U.S. Department
of Transportation
**Federal Highway
Administration**

October 20, 1997

In your August 13 letter to Mr. James H. Hatton of my staff you requested Federal Highway Administration's (FHWA) acceptance of the connection design used in your precast concrete median barrier. This request was accompanied by a Texas Transportation Institute research report dated July 1997, entitled "NCHRP Report 350 Compliance Tests on Rockingham Precast Concrete Barriers," and a videotape showing the full scale testing that was done.

Geometric and Safety Design Group Acceptance Letter B-42.

Figure 10. Summary of results for test 400001-RPC1.

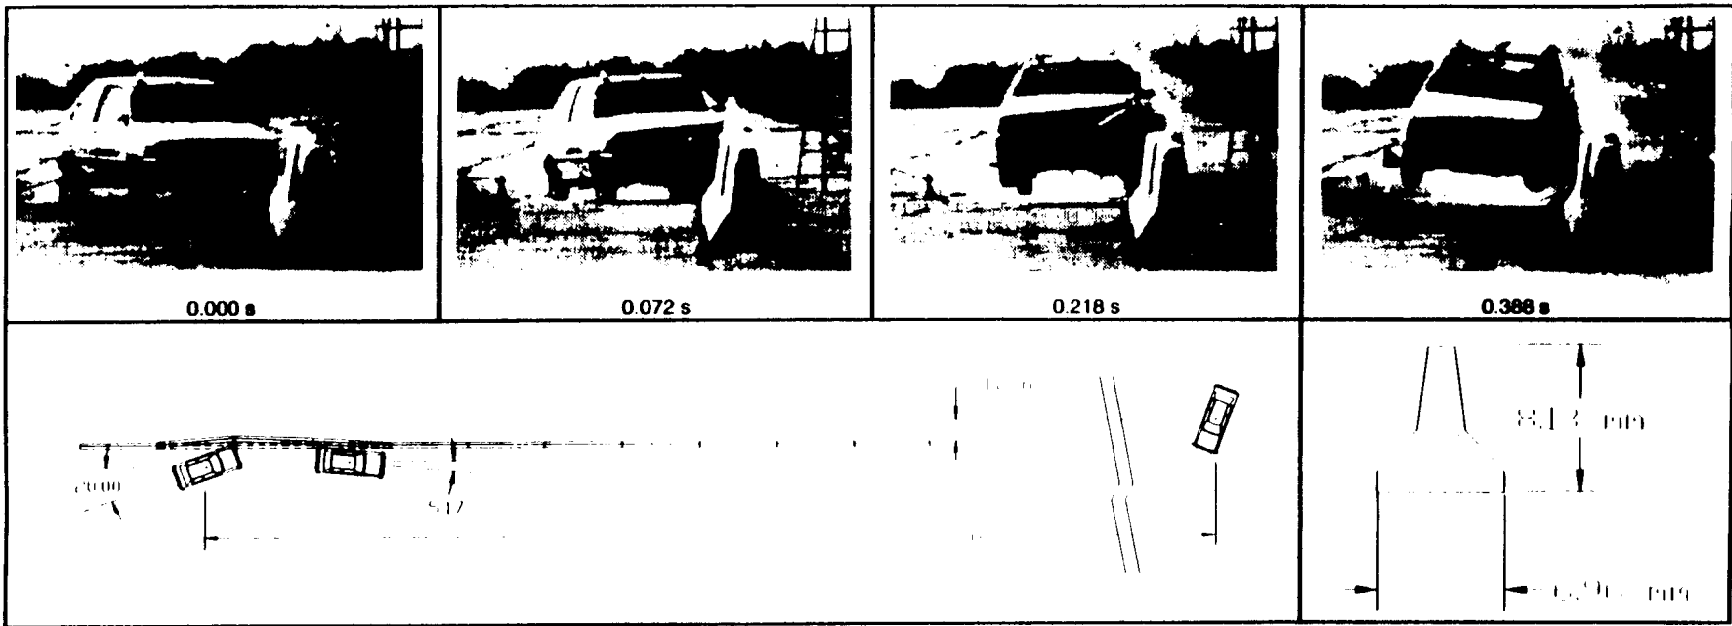
Three National Cooperative Highway Research Program (NCHRP) Report 350 tests were run on a 47.55-m long installation. The first test (NCHRP Report 350 test 3-10) resulted in acceptable **performance with the containment and redirection of the 820-kg car impacting at a nominal speed of 100 km/h and an angle of 20 degrees.** The impact point was 10.14 m from the **upstream end.** **Permanent** deflection was 180 mm. The second test, with a 2000-kg pickup truck **impacting at 100 km/h and at an angle of 25 degrees** (NCHRP Report 350 test 3-11), **resulted in the separation of the barrier as a result of severe damage to several of the connections.** The connections were redesigned (the final design is shown in Enclosure 1) and the third test, a repeat of the 3-11 test, met all evaluation criteria. The impact point for this test was 17.26 m from the upstream end. Permanent barrier deflection was 1150 mm.

Figure 16. Summary of results for test 400001-RPC3.

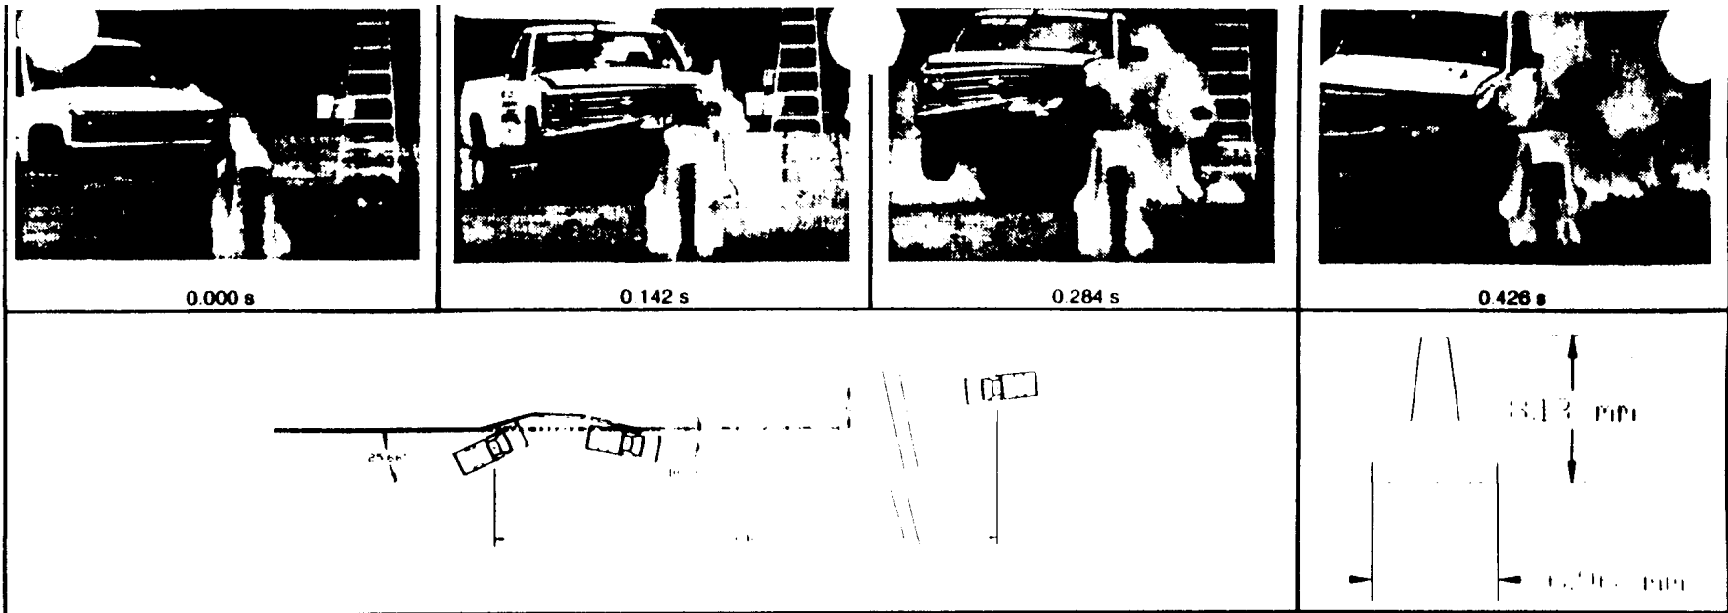
All segments were standing on a concrete surface and there was no deflection of the end units. Based on the test, we suggest that the length of need for unanchored units begin a minimum of approximately 18 m upstream from the point at which the barrier is introduced and extend a similar distance beyond the end of the length of need when this system is used on high-speed routes. Summary data for the first and third tests are shown in Enclosure 2. The maximum roll, pitch, and yaw angles were 34 degrees, 15 degrees, and 13 degrees, respectively.

Based on our review of the information you submitted, we agree that the Rockingham CMB Connection as described above and used with an F-shape concrete barrier configured as tested in the passing 3-11 test satisfies the evaluation criteria for a NCHRP Report 350 test level 3 (TL-3) barrier. Thus, it may be used for temporary barrier installations on the NHS when such use is requested by a State highway agency. Since your design is patented, its use on Federal-aid projects, except exempt, non-NHS projects, is subject to the conditions listed in Title 23, Code of Federal Regulations, Section 635.411, a copy of which is enclosed as Enclosure 3.
